The Commission has issued the enclosed Amendment No. 50 to Provisional Operating License No. DPR-19 for Dresden Station Unit 2 and Amendment Nos. 59 and 54 to Facility Operating License Nos. DPR-29 and DPR-30 for Quad Cities Station Units 1 and 2, respectively. The amendments are in response to your letter of March 19, 1980.

The amendments establish MAPLHGR limits for standard 8x8 (8D250 and 8D262) fuel types for exposure values beyond those currently given in the Technical Specifications.

SAFETY EVALUATION BY THE OFFICE OF NUCLEAR REACTOR REGULATION
SUPPORTING AMENDMENT NO. 50 TO PROVISIONAL OPERATING LICENSE NO. DPR-19,
AMENDMENT NO. 59 TO FACILITY OPERATING LICENSE NO. DPR-29, AND
AMENDMENT NO. 54 TO FACILITY OPERATING LICENSE NO. DPR-30

FIGURE 3.5-1
(Sheet 1 of 4)

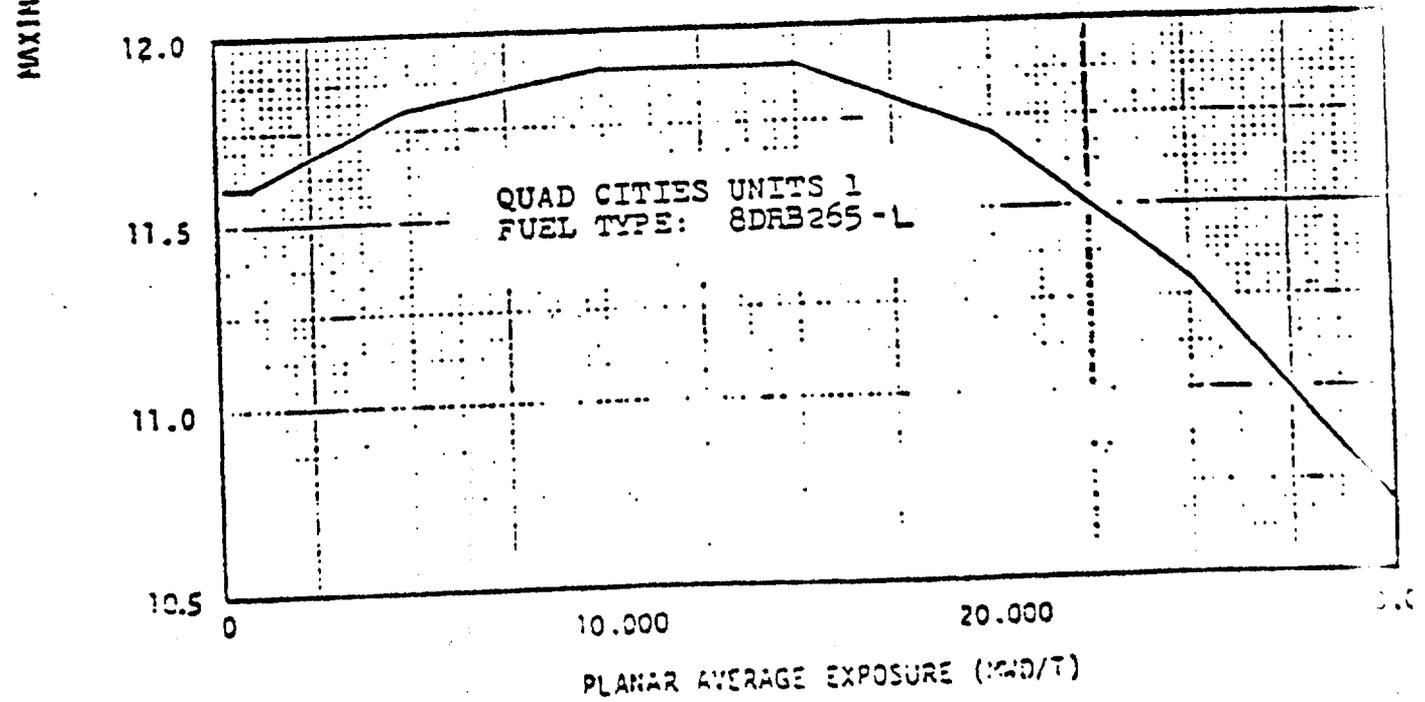
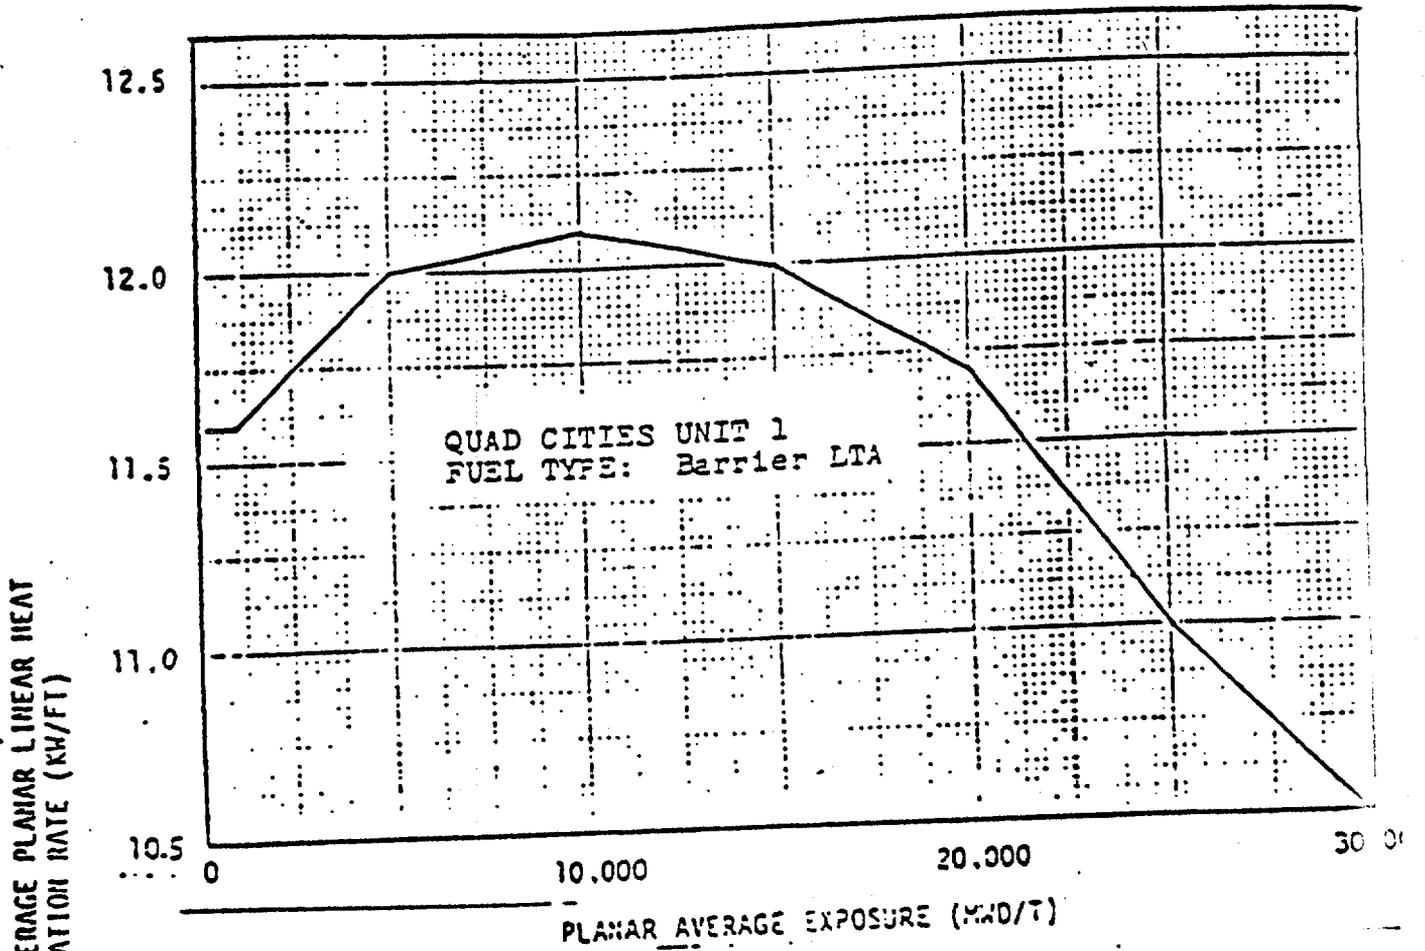
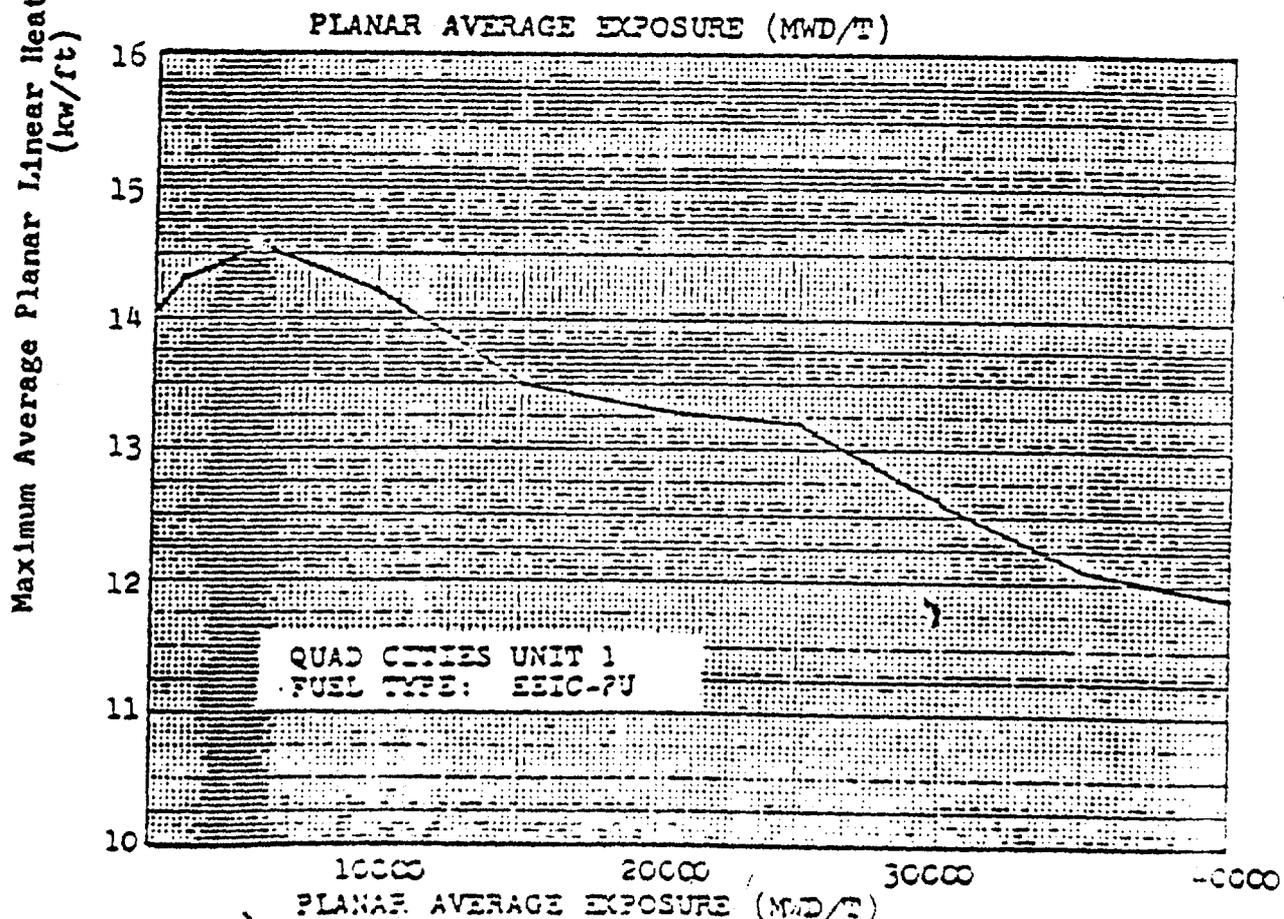
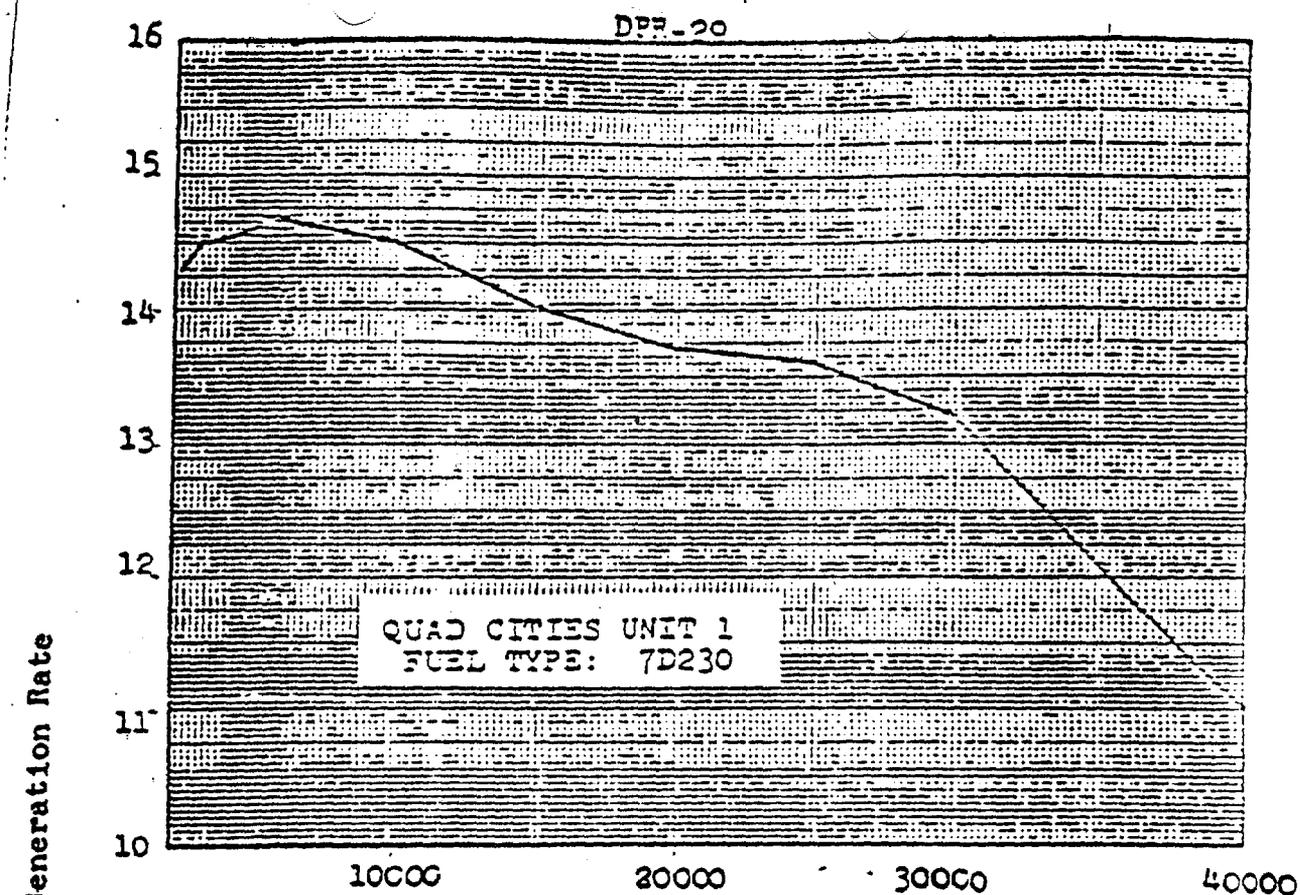
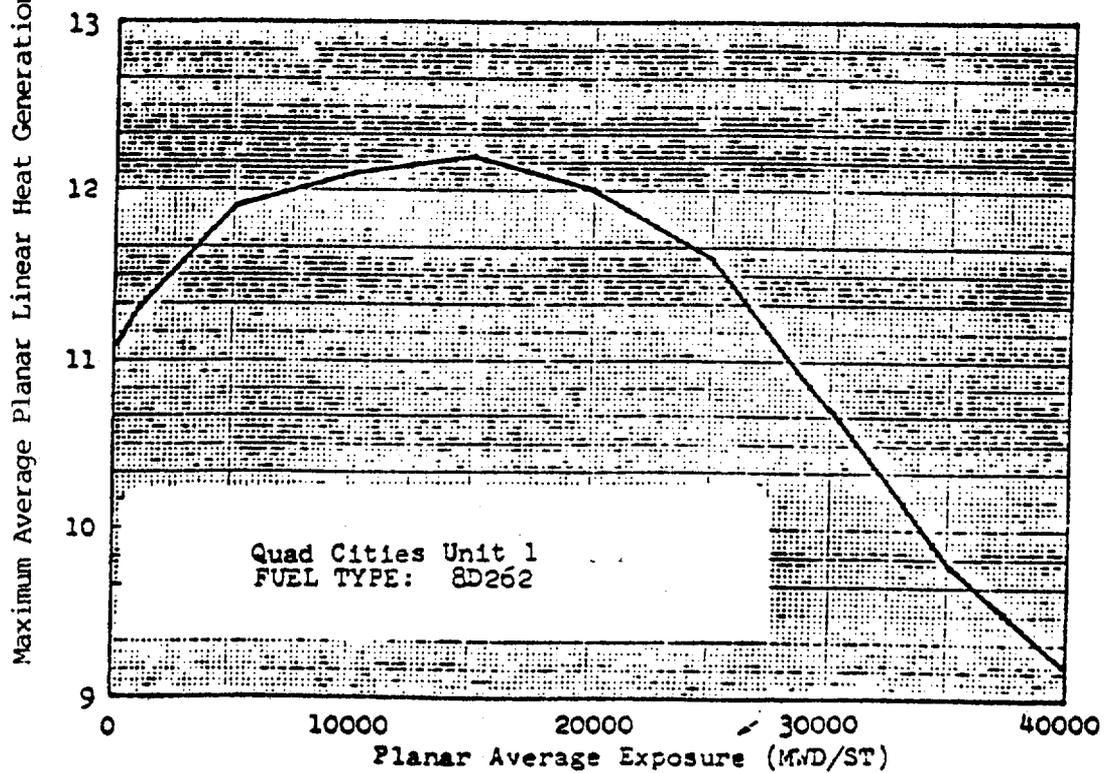
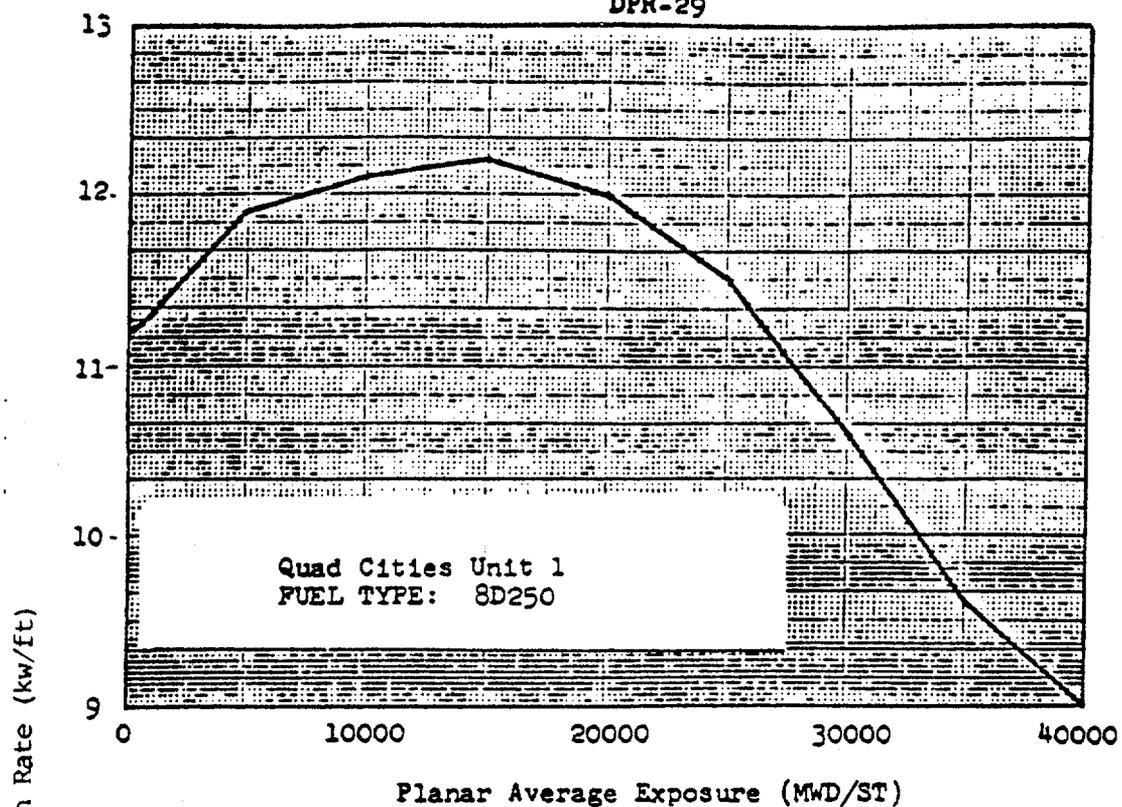
During steady-state power operation, the average linear heat generation rate (APLHGR) of all the rods in any fuel assembly, as a function of average planar exposure, at any axial location, shall not exceed the maximum average planar LHGR shown in Figure 3.5-1.
